D3702-1 FORWARD DOUBLER

RELEASED
09/04/09 JP

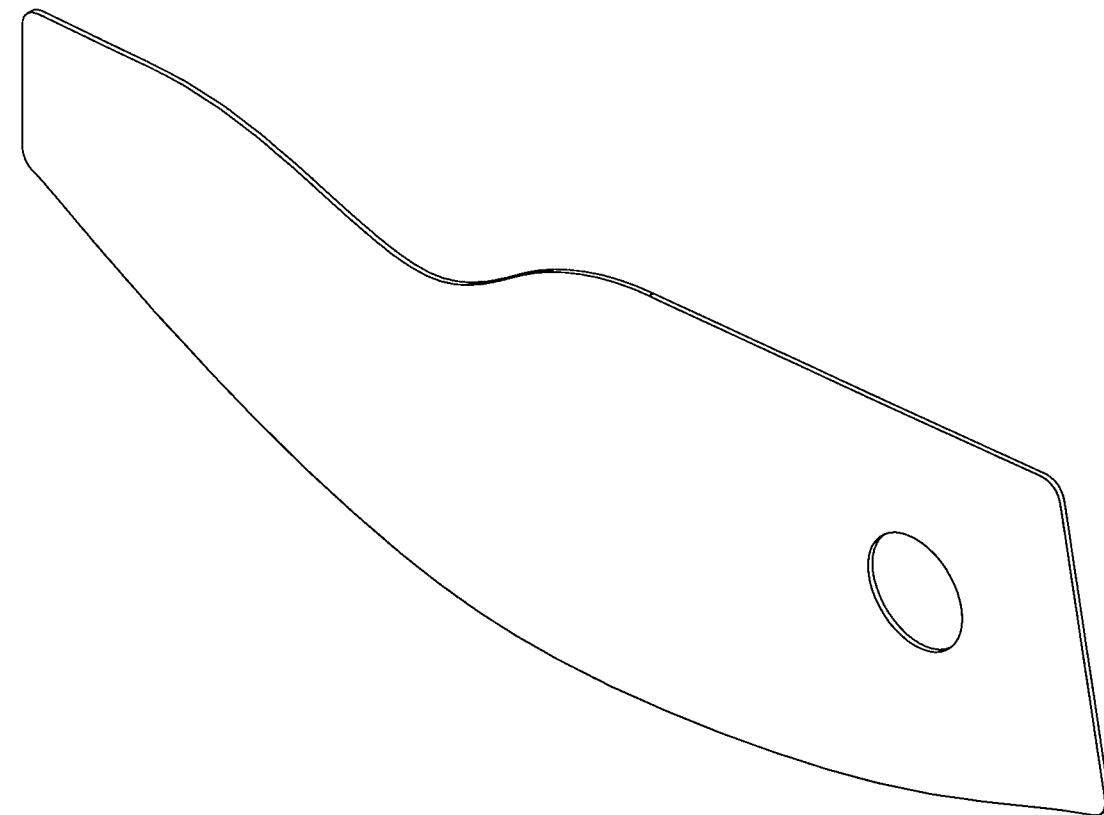
B	Ø1.375 WAS Ø1.25 (ZN B5-2) REASON: HOLE ENLARGED FOR INSTALLATION OF GROMMET	MB	08.07.10
A	NEW ISSUE	MB	08.04.30
REV.	DESCRIPTION	BY	DATE
DESIGN	1b	DART AEROSPACE LTD	
DRAWN	2	HAWKESBURY, ONTARIO, CANADA	
CHECKED	AB	DRAWING NO.	REV. B
MFG. APPR.	AB	D3702	SHEET 1 OF 2
APPROVED	AB	TITLE	SCALE
DE APPR.	AB	FORWARD DOUBLER	NTS
DATE	08.07.10	COPYRIGHT © 2008 BY DART AEROSPACE LTD THIS DOCUMENT IS PRIVATE AND CONFIDENTIAL AND IS SUPPLIED ON THE EXPRESS CONDITION THAT IT IS NOT TO BE USED FOR ANY PURPOSE OR COPIED OR COMMUNICATED TO ANY OTHER PERSON WITHOUT WRITTEN PERMISSION FROM DART AEROSPACE LTD
